Access Audit Site Report

Brazos Bend State Park
21901 Farm to Market Rd 762
Needville, TX 77461
Accessibility Evaluation
Inspection Date: 06/14/2021
Inspectors: Tanya Scheibe

**AMERICANS WITH DISABILITIES ACT COMPLIANCE INITIATIVE
PROGRAM AND POLICY REPORT
JULY 28, 2023**

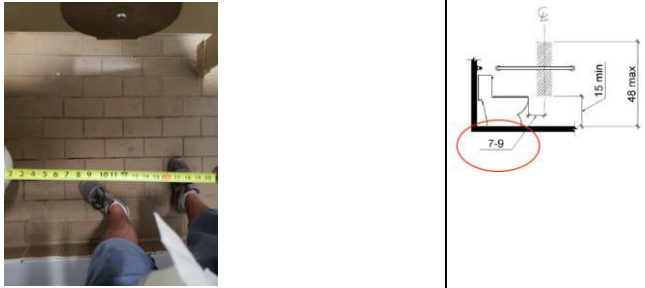
Finding Number	Area Description	Lat/Long	Finding	As Built	Recommendation	Citation	Photos	Figure
36	40 Acre Lake: Parking - 40 Acre Lake	[29.3708093, -95.6273322]	At least one accessible route shall connect accessible buildings, accessible facilities, accessible elements, and accessible spaces that are on the same site. For areas of sport activity, an accessible route is required to connect to the boundary of each area of sport activity. The size of an area of sport activity includes only the space needed to play. Where multiple sports fields or courts are provided, an accessible route is required to each field or area of sport activity.	Lacks accessible route to bike rack	Provide an accessible route to each element within the site.	2010 ADAS Section: 206.2.2, 206.2		
37	40 Acre Lake: 40 Acre Lake Restrooms	[29.370706, -95.6270939]	The tactile restroom wall sign is missing the International Symbol of Accessibility (ISA). Accessible toilet rooms or bathing rooms shall be identified by the International Symbol of Accessibility (ISA). Wall signs identifying permanent rooms and spaces of a building shall have be horizontal format and the characters raised 1/32 inch minimum and shall be sans serif uppercase characters a minimum of 5/8 inch and a maximum of 2 inches high. Contracted Grade 2 Braille shall be in a horizontal format and shall be placed a minimum of 3/8 inch and a maximum of 1/2 inch directly below the tactile characters; flush left or centered. Signs with raised characters or Braille shall be located 48 inches minimum above the finish floor or ground surface, measured from the baseline of the lowest tactile character and 60 inches maximum above the finish floor or ground surface, measured from the baseline of the highest tactile character.	Men's restroom - Lacks signage with the International Symbol of Accessibility (ISA)	Acquire and mount signage, including access symbol Acquire and mount signage, including Braille and access symbol mounted on wall, latch side of door, 48" to baseline of lowest character and 60" to baseline of highest character	2015 ABAAS Section: F216.8 2012 TAS Section: 216.8 2010 ADAS Section: 216.8

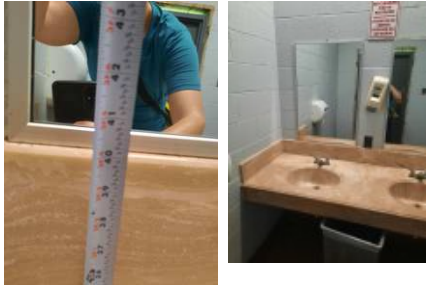
44	40 Acre Lake: 40 Acre Lake Restrooms	[29.370706, -95.6270845]	The stall door fails to comply with all of the door requirements. The stall door must be a minimum of 32" wide and have compliant hardware on both sides. The stall door must be self-closing.	Men's restroom - Lacks self-closing door, and lacks compliant hardware	Adjust stall door to be self-closing Replace stall hardware with hardware operable without a tight pinch or grasp on both sides of the stall door	2015 ABAAS Section: 404.2.3, 404.2.7, 604.8.2.2 2012 TAS Section: 404.2.3, 404.2.7, 604.8.2.2 2010 ADAS Section: 404.2.3, 404.2.7, 604.8.2.2

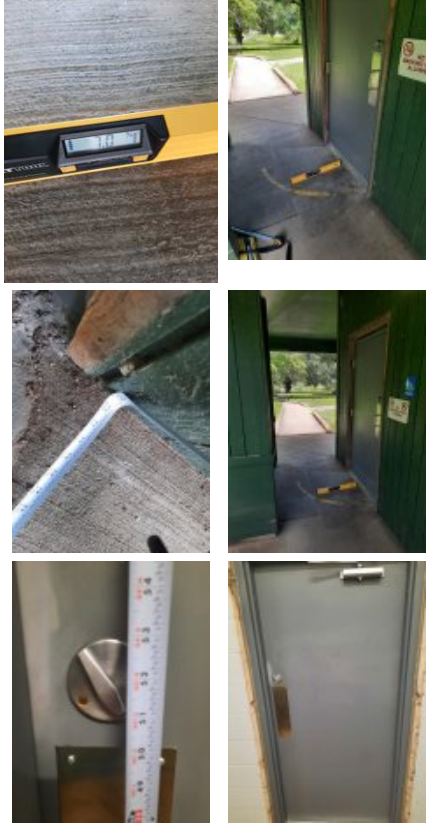
Finding Number	Area Description	Lat/Long	Finding	As Built	Recommendation	Citation	Photos	Figure
51	40 Acre Lake: 40 Acre Lake Restrooms	[29.3707095 , -95.627096 6]	The mirror is mounted too high. Mirrors must have the bottom edge of the reflecting surface a maximum of 40 inches above the floor if above a sink or counter. Mirrors not located above lavatories or countertops shall be installed with the bottom edge of the reflecting surface 35 inches maximum above the finish floor or ground.	Women's restroom - Bottom edge of reflecting surface of mirror is 40.75" aff	Lower mirror so reflective surface is max 40" aff	2015 ABAAS Section: 603.3 2012 TAS Section: 603.3 2010 ADAS Section: 603.3		
52	40 Acre Lake: 40 Acre Lake Restrooms	[29.370706, -95.627103 3]	Knee clearance at 27 inches off the floor is not 8 inches minimum deep. The knee clearance, measured from the bottom of the apron or the outside bottom edge of the lavatory, must be 27 inches at a point located 8 inches back from the front edge and continuing to 11 inches minimum in depth at 9 inches above the floor. The top of the lavatory rim may be no higher than 34 inches.	Women's restroom - Sink lacks 8" deep knee clearance due to garbage can in clear floor space	Relocate obstacles to provide knee clearance and clear floor space at sink	2015 ABAAS Section: 306.3.1, 306.3.2, 306.3.3, 306.3.4 , 306.3.5 2012 TAS Section: 306.3.2, 306.3.3, 306.3.4, 306.3.5, 306.3.1 2010 ADAS Section: 306.3.3, 306.3.2, 306.3.4, 306.3.5, 306.3.1

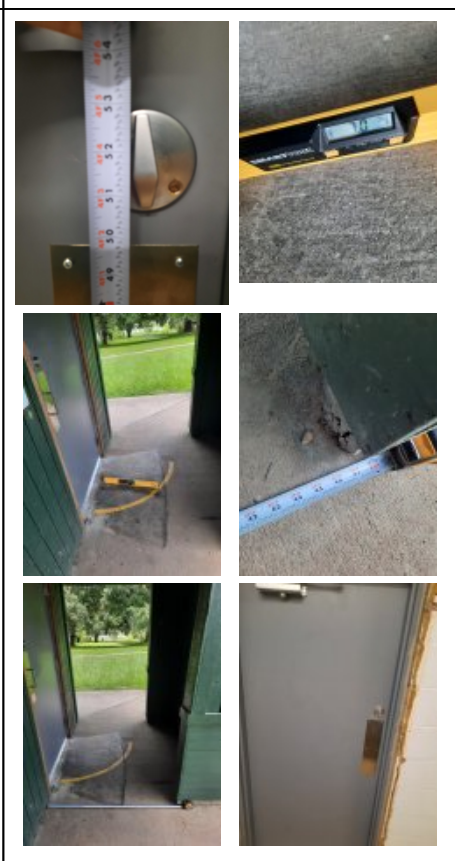
55	40 Acre Lake: 40 Acre Lake Restrooms	[29.3707001 , -95.627093 9]	The ambulatory stall is not between 35" to 37" wide and 60" deep.	Women's restroom - Stall lacks required dimensions to be an ambulatory stall (38" wide)	Correct ambulatory stall to be 35" to 37" wide and minimum 60" deep	2015 ABAAS Section: 604.8.2.1 2012 TAS Section: 604.8.2.1 2010 ADAS Section: 604.8.2.1

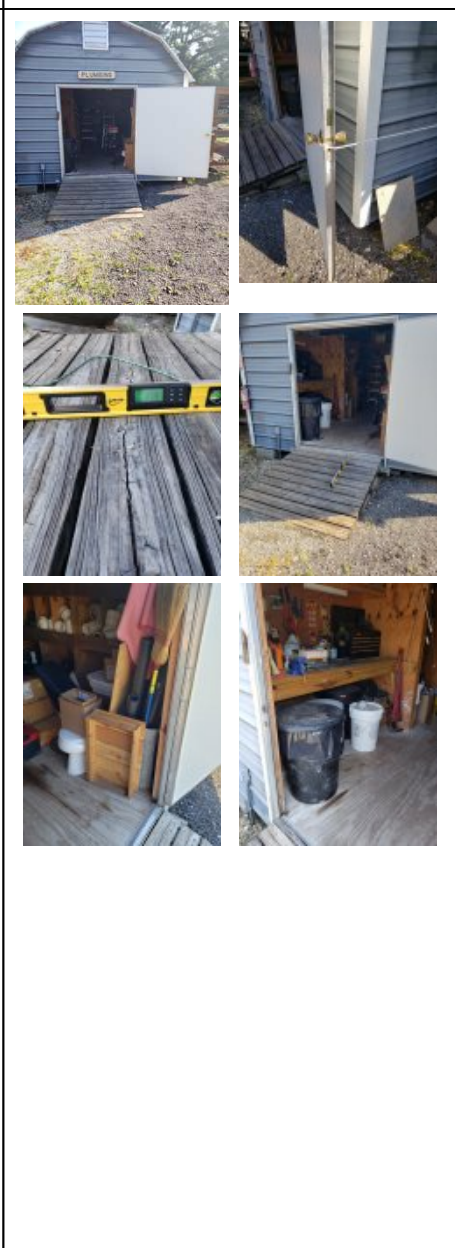
Finding Number	Area Description	Lat/Long	Finding	As Built	Recommendation	Citation	Photos	Figure
74	Employee Spaces: Maintenance	[29.3691784 , -95.596988 8]	Minimum maneuvering clearances at doors and gates shall comply with 404.2.4. Maneuvering clearances shall extend the full width of the doorway and the required latch side or hinge side clearance. Floor or ground surface within required maneuvering clearances shall comply with 302. Changes in level are not permitted. EXCEPTIONS: 1. Slopes not steeper than 1:48 shall be permitted. Hand-activated door opening hardware, handles, pulls, latches, locks, and other operating devices on accessible doors shall have a shape that is easy to grasp with one hand and does not require tight grasping, tight pinching or twisting of the wrist to operate. Hardware shall be 34 inches minimum and 48 inches maximum above the finish floor or ground.	Paint building door - slope of 5.9% in pull side clearance, storage in push side clearance, knobs, and door latch is 60" aff	For all doors along the public circulation route, provide required maneuvering clearance on push and pull side of doors Correct or repair slope at doorway landing to max 2.08% in any direction for level For all doors along the public circulation route, replace doors with doors having 80" overhead clearance and 32" clear width For all doors along the public circulation route, replace hardware with lever hardware or hardware operable without a tight pinch or grasp For all doors along the public circulation route, remount hardware to be 34" to 48" aff	2010 ADAS Section: 404.2.3, 404.2.7, 404.2.4, 404.2.11, 404.2.11 Exception

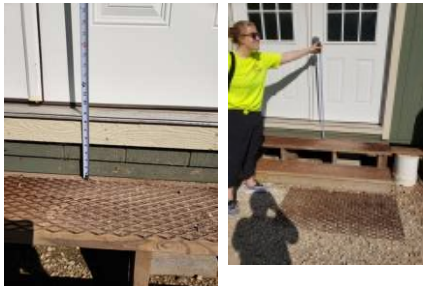
Finding Number	Area Description	Lat/Long	Finding	As Built	Recommendation	Citation	Photos	Figure
80	Employee Spaces: Maintenance	[29.3691831 , -95.596956 6]	Minimum maneuvering clearances at doors and gates shall comply with 404.2.4. Maneuvering clearances shall extend the full width of the doorway and the required latch side or hinge side clearance. Floor or ground surface within required maneuvering clearances shall comply with 302. Changes in level are not permitted. EXCEPTIONS: 1. Slopes not steeper than 1:48 shall be permitted. Hand-activated door opening hardware, handles, pulls, latches, locks, and other operating devices on accessible doors shall have a shape that is easy to grasp with one hand and does not require tight grasping, tight pinching or twisting of the wrist to operate. Hardware shall be 34 inches minimum and 48 inches maximum above the finish floor or ground. The accessible route contains loose gravel and/or surfaces that do not provide for a stable, firm slip resistant surface.	Plumbing building door - Lacks maneuvering clearance on push side (storage) and pull side (slope of 17.9%), lacks compliant hardware (knobs), and lacks firm and stable approach (deteriorated asphalt and loose gravel)	For all doors along the public circulation route, provide required maneuvering clearance on push and pull side of doors Correct or repair slope at doorway landing to max 2.08% in any direction for level For all doors along the public circulation route, replace hardware with lever hardware or hardware operable without a tight pinch or grasp Resurface AR where deterioration occurs	2010 ADAS Section: 404.2.3, 404.2.7, 404.2.4, 404.2.11, 404.2.11 Exception

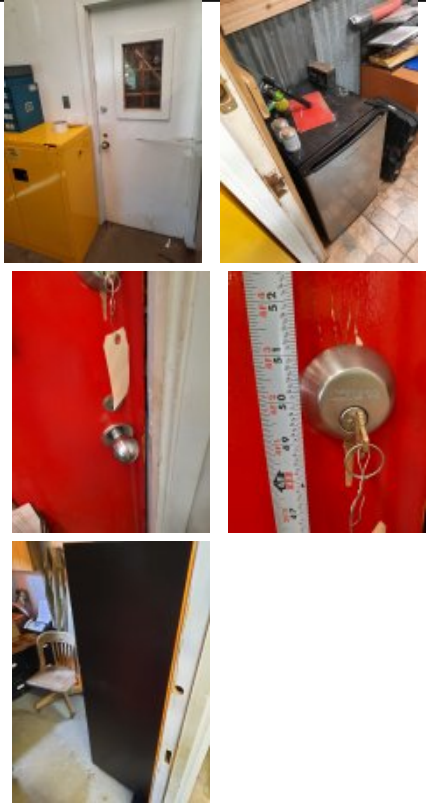
85	Employee Spaces: Maintenance	[29.3691831 , -95.596962]	The door operating hardware is not accessible. Hand-activated door opening hardware, handles, pulls, latches, locks, and other operating devices on accessible doors shall have a shape that is easy to grasp with one hand and does not require tight grasping, tight pinching or twisting of the wrist to operate. Hardware shall be 34 inches minimum and 48 inches maximum above the finish floor or ground.	Ranger hut door - knobs	Replace hardware with lever hardware or hardware operable without a tight pinch or grasp	2015 ABAAS Section: 404.2.7 2012 TAS Section: 404.2.7 2010 ADAS Section: 404.2.7

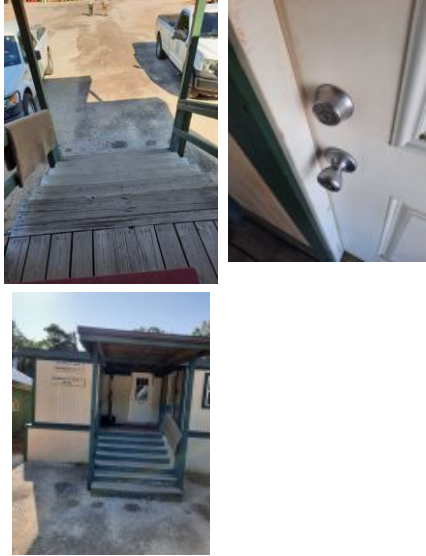
Finding Number	Area Description	Lat/Long	Finding	As Built	Recommendation	Citation	Photos	Figure
99	Employee Spaces: Maintenance	[29.3692088 , -95.596954]	The restroom sign does not comply with one or more applicable requirements for the location, height, and properties of the sign.	Ranger hut - Lacks compliant signage	Acquire and mount signage, including Braille and access symbol mounted on wall, latch side of door, 48" to baseline of lowest character and 60" to baseline of highest character	2015 ABAAS Section: F216.2, 703.1, 703.2, 703.5, 703.6 2012 TAS Section: 216.2, 703.1, 703.2, 703.5, 703.6 2010 ADAS Section: 216.2, 703.1, 703.2, 703.5, 703.6		
100	Employee Spaces: Maintenance	[29.3691738 , -95.5969835]	Spaces and elements within employee work areas shall only be required to comply with 206.2.8, 207.1, and 215.3 and shall be designed and constructed so that individuals with disabilities can approach, enter, and exit the employee work area. Employee work areas, or portions of employee work areas, other than raised courtroom stations, that are less than 300 square feet (28 m2) and elevated 7 inches (180 mm) or more above the finish floor or ground where the elevation is essential to the function of the space shall not be required to comply with these requirements or to be on an accessible route.	Ranger hut - back door: 6 steps, no MC on pull, loose rug in doorway	For employee spaces, relocate storage, furniture, and other obstacles at doorways to provide approach, enter and exit at the employee space.	2015 ABAAS Section: F203.9 2012 TAS Section: 203.9 2010 ADAS Section: 203.9

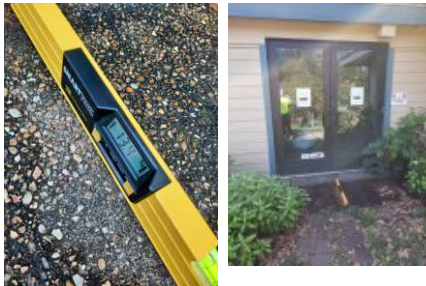
114	Employee Spaces: Residences	[29.3688605 , -95.598464]	The accessible route contains loose gravel and/or surfaces that do not provide for a stable, firm slip resistant surface.	Lacks firm and stable surface on accessible route to Residence #1	Resurface AR where deterioration occurs	2015 ABAAS Section: 302.1 2012 TAS Section: 302.1 2010 ADAS Section: 302.1

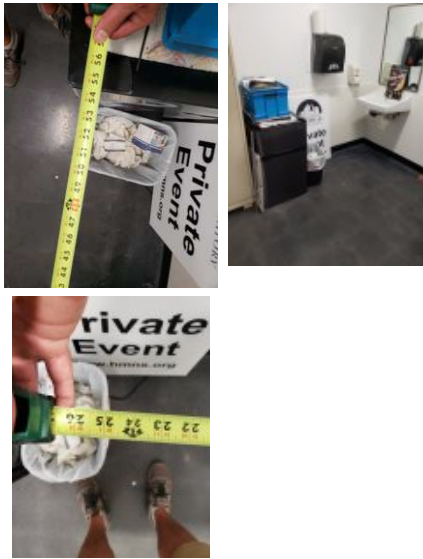
Finding Number	Area Description	Lat/Long	Finding	As Built	Recommendation	Citation	Photos	Figure
154	Creekfield Lake Area: Nature Center Restrooms	[29.3763426, -95.5968359]	The toilet is not located within the range to the side wall or partition. The centerline of the toilet shall be 17 inches minimum and 19 inches maximum side wall or partition in the ambulatory accessible toilet compartment.	Women's restroom - Centerline of the toilet is 21" from the right-side wall and 15" from the left-side wall	Remount toilet to 17" to 19" from the side wall to center line in ambulatory stalls	2015 ABAAS Section: 604.9.1 2012 TAS Section: 604.9.1 2010 ADAS Section: 604.9.1		
155	Creekfield Lake Area: Nature Center Restrooms	[29.3763426, -95.5968252]	The stall door fails to comply with all of the door requirements. The stall door must be a minimum of 32" wide and have compliant hardware on both sides. The stall door must be self-closing.	Women's restroom - Lacks self-closing door	Adjust stall door to be self-closing	2015 ABAAS Section: 404.2.3, 404.2.7, 604.8.2.2 2012 TAS Section: 404.2.3, 404.2.7, 604.8.2.2 2010 ADAS Section: 404.2.3, 404.2.7, 604.8.2.2

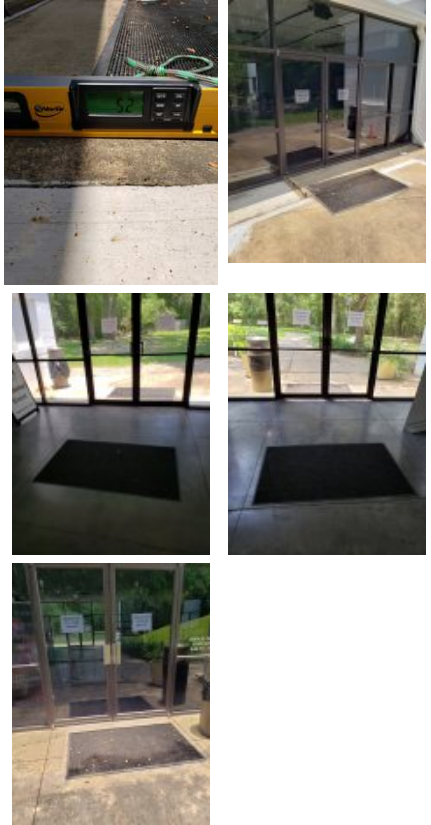
162	Creekfield Lake Area: George Observatory	[29.3750804 , -95.593617 3]	The operable part is not accessible because there is not adequate clear floor space for either a forward or side approach. The clear floor or ground space shall be 30 inches minimum by 48 inches minimum.	Mission Control Bathroom - Sink and paper towel dispenser lack clear floor space due to storage, garbage can, and mini fridge in cfs	Remove, or relocate storage in CFS at fixtures and operable parts along the AR	2015 ABAAS Section: 305.3 2012 TAS Section: 305.3 2010 ADAS Section: 305.3

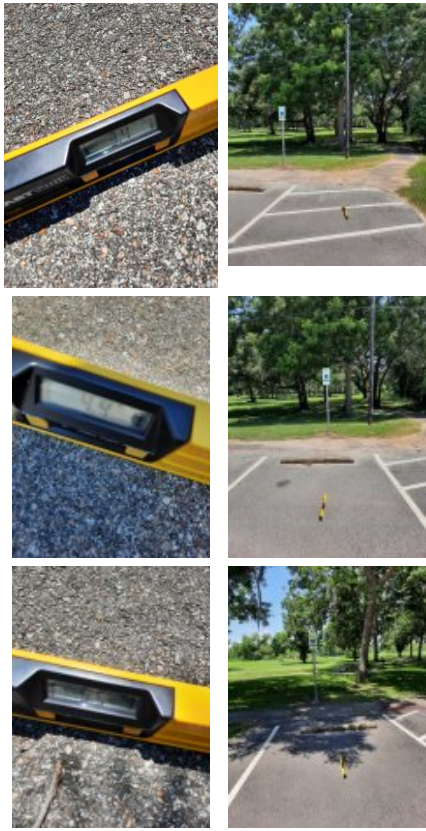
Finding Number	Area Description	Lat/Long	Finding	As Built	Recommendation	Citation	Photos	Figure
215	Creekfield Lake Area: George Observatory	[29.37517, -95.59409]	Benches shall have a 36" by 48" clear ground space (CGS) positioned near the bench with one side of the space adjoining an outdoor recreation access route (ORAR) or trail, as applicable The CGS shall not overlap with the ORAR or trail or another CGS As a smart practice, add at least one armrest and achieve height of bench seat of 17" to 19"	Lacks clear ground space adjacent to 4 of 4 benches	Construct firm, stable, and slip resistant pads at least 36" by 48" adjacent to 20% of benches, and locate along an AR as a smart practice	2015 ABAAS Section: 1011.2.1		
216	Creekfield Lake Area: George Observatory	[29.3752714, -95.5938163]	The accessible route contains loose gravel and/or surfaces that do not provide for a stable, firm slip resistant surface.	Lacks firm and stable surface on accessible route to west entry due to deterioration of asphalt and upheaval of pavers (tree roots)	Resurface AR where deterioration occurs	2015 ABAAS Section: 302.1 2012 TAS Section: 302.1 2010 ADAS Section: 302.1

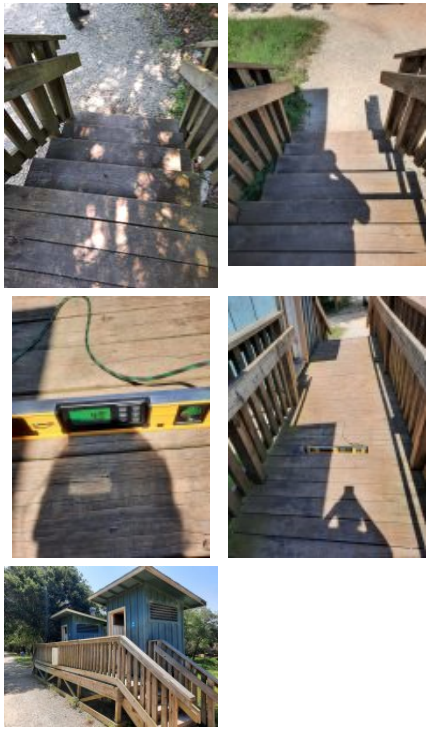
231	Elm Lake Area: Elm Lake Restrooms	[29.3778127 , -95.605121 3]	The water and drain pipes under the lavatory are not adequately insulated. Water supply and drain pipes under lavatories and sinks shall be insulated or otherwise configured to protect against contact. There shall be no sharp or abrasive surfaces under lavatories and sinks.	Women's restroom - Sink lacks insulated pipes	Insulate exposed pipes under one sink	2015 ABAAS Section: 606.5 2012 TAS Section: 606.5 2010 ADAS Section: 606.5		
232	Elm Lake Area: Elm Lake Restrooms	[29.3778081 , -95.605115 9]	There are not enough accessible toilet compartments. The room contains several toilet compartments. A minimum of 1 must be wheelchair accessible .	Women's restroom - ambulatory only	Create a wheelchair accessible stall with grab bars and fixtures mounted in correct locations and at correct heights	2015 ABAAS Section: F213.3.1 2012 TAS Section: 213.3.1 2010 ADAS Section: 213.3.1

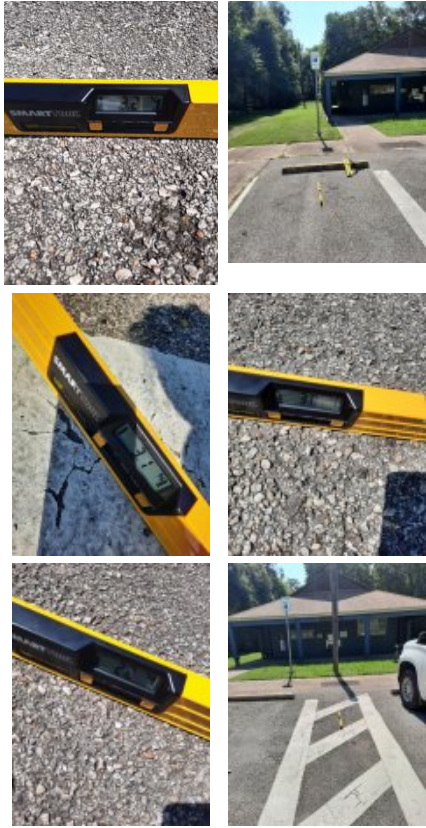
269	Camping Area: Camping	[29.3825153 , -95.599925 8]	An accessible access route is not provided between elements, spaces and the facilities provided within the accessible camping unit. At least one outdoor recreation access route shall connect accessible elements, spaces and facilities provided within camping units with mobility features. 48 inches (1220 mm) by 48 inches (1220 mm) on all usable sides of the fire ring, grill, fireplace, and woodstove. Center the space on each usable side of the grill, fireplace, and woodstove.	Site 231 - Lacks accessible route to and 48" by 48" clear ground space on all usable sides of the fire ring	Create AR with crushed and compacted stone or similar outdoor material to fire ring, with a 48" x 48" clear space around usable area	2015 ABAAS Section: F244.5.1		
270	Camping Area: Camping	[29.3824989 , -95.599877 6]	Fire building surfaces shall be 9 inches (230 mm) minimum above the ground	Site 231 - Fire building surface lacks 9" minimum above surrounding ground level	Correct fire building surface to be 9" min above the ground as a smart practice.	2015 ABAAS Section: 1011.5.1

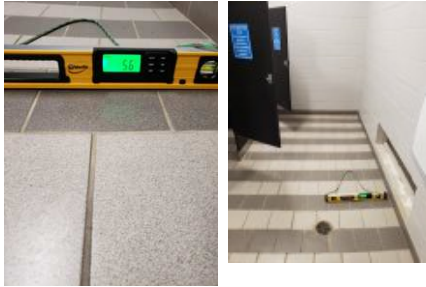
275	Camping Area: Parking - Camping Restrooms 1	[29.3805041, -95.5957818]	The access aisle is not a minimum 5 feet wide. A car accessible parking stall's access aisle must be a minimum of 5 feet wide measured from centerline to centerline. Where the access aisle is not adjacent to another parking space or access aisle, measurements shall be permitted to include the full width of the line defining the access aisle.	Access aisle 2 - 50.5" wide	Repaint access aisles to be 5' each	2015 ABAAS Section: 502.3.1 2012 TAS Section: 502.3.1 2010 ADAS Section: 502.3.1

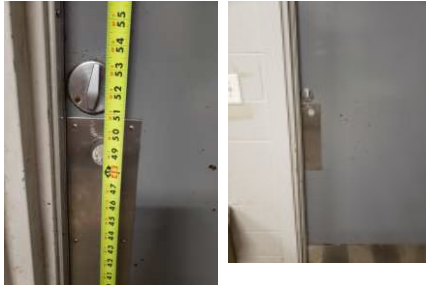
286	Camping Area: Camping Restrooms 1	[29.3804795 , -95.595594 1]	The top rim of the sink is too high. All lavatories/sinks that are designated to be accessible shall be a minimum 17 inches in horizontal depth and mounted with the rim or counter edge no higher than 34 inches above the finished floor.	Women's restroom - rim of the sink is 35" aff	Lower sinks to max 34" aff to front of rim	2015 ABAAS Section: 606.3 2012 TAS Section: 606.3 2010 ADAS Section: 606.3

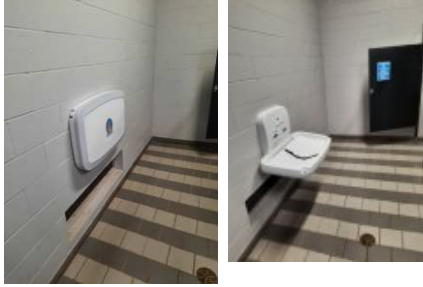
296	Camping Area: Camping Restrooms 2	[29.3820548 , -95.598230 7]	The door operating hardware is not located within the compliant range. Hand-activated door opening hardware, handles, pulls, latches, locks, and other operating devices on accessible doors shall have a shape that is easy to grasp with one hand and does not require tight grasping, tight pinching or twisting of the wrist to operate. Hardware shall be centered between 34 inches and 48 inches above the floor.	Men's restroom door - hardware (deadbolt) lacks required mounting height above ground level - 52" agl	For all doors along the public circulation route, replace hardware with lever hardware where indicated, mounted 34" to 48" aff	2015 ABAAS Section: 404.2.7 2012 TAS Section: 404.2.7 2010 ADAS Section: 404.2.7		
297	Camping Area: Camping Restrooms 2	[29.3820221 , -95.598228]	It is recommended that exterior doors be maintained so that the operating pressure does not exceed 8.5 lb. force to open. The sweep period for doors with closers shall be adjusted so that from an open position of 70 degrees, the door will take at least 3 seconds to move to a point 7 inches from the latch, measured to the leading edge of the door.	Men's restroom door - 15# push	For all doors along the public circulation route, inspect, adjust, and maintain 8.5 lbf to open exterior doors as a smart practice For all doors along the public circulation route, inspect, adjust, and maintain closing speed on door closers	2012 TAS Section: 404.2.9, 404.2.9 Advisory, 404.2.8.1 2010 ADAS Section: 404.2.9, 404.2.8.1

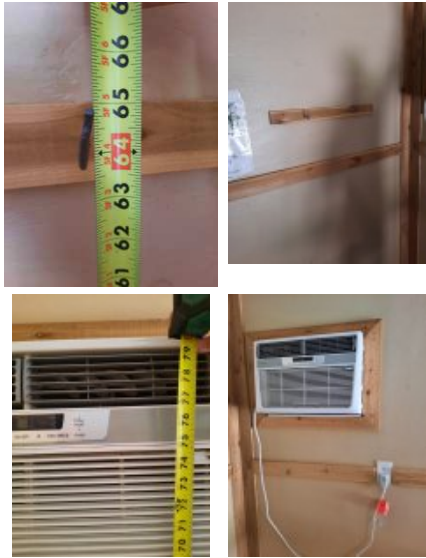
Finding Number	Area Description	Lat/Long	Finding	As Built	Recommendation	Citation	Photos	Figure
336	Camping Area: Camping Dining Hall	[29.3812485 , -95.598713 5]	The toilet is not located within the range allowed from the side wall or partition. The centerline of the toilet must be 16 to 18 inches from the side wall.	Restroom - Centerline of the toilet is 25" from the side wall	Remount toilets to 16" to 18" from the side wall to centerline	2015 ABAAS Section: 604.2 2012 TAS Section: 604.2 2010 ADAS Section: 604.2		
337	Camping Area: Camping Dining Hall	[29.3812485 , -95.598710 8]	The rear grab bar is not 36" long or is not mounted in the correct location. The rear grab bar must be a minimum of 36" long and extend from the toilet centerline a minimum 12" towards the wall side and a minimum 24" towards the open side of the toilet. Grab bars shall be installed in a horizontal position, 33 inches minimum and 36 inches maximum above the finish floor measured to the top of the gripping surface and the space between the grab bar and the top of the tank shall be 1-1/2 inches minimum.	Restroom - Rear grab bar extends 18.5" from centerline of toilet towards the open side of the toilet	Remount rear grab bar to behind the toilet, 12" to one side of center and 24" to the other and 33" to 36" aff Remount rear grab bar to behind the toilet, 12" to one side of center and 24" to the other and 33" to 36" aff	2015 ABAAS Section: 604.5.2 2012 TAS Section: 604.5.2 2010 ADAS Section: 604.5.2

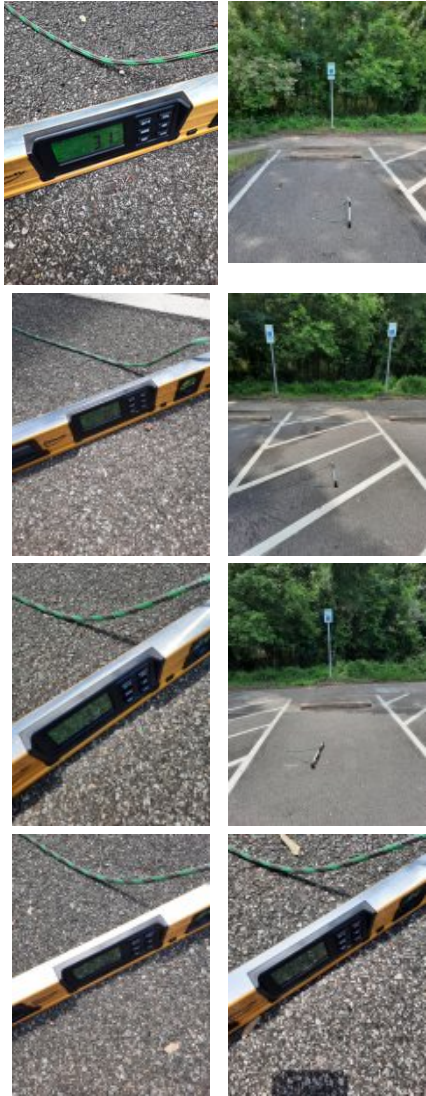
343	Camping Area: Camping Dining Hall	[29.3812532, -95.598721 5]	Minimum maneuvering clearances at doors and gates shall comply with 404.2.4. Maneuvering clearances shall extend the full width of the doorway and the required latch side or hinge side clearance. Floor or ground surface within required maneuvering clearances shall comply with 302. Changes in level are not permitted. EXCEPTIONS: 1. Slopes not steeper than 1:48 shall be permitted. Exterior doors are recommended to be maintained at 8.5 lbf as a smart practice. Force is to be measured at the operating hardware or 30 inches from the hinges, whichever is greater.	Double entry doors - slope of 8.4%, 10# push - left door	For all doors along the public circulation route, provide required maneuvering clearance on push and pull side of doors Correct or repair slope at doorway landing to max 2.08% in any direction for level For all doors along the public circulation route, inspect, adjust, and maintain 8.5 lbf to open exterior doors as a smart practice	2010 ADAS Section: 404.2.3, 404.2.7, 404.2.4, 404.2.11, 404.2.11 Exception
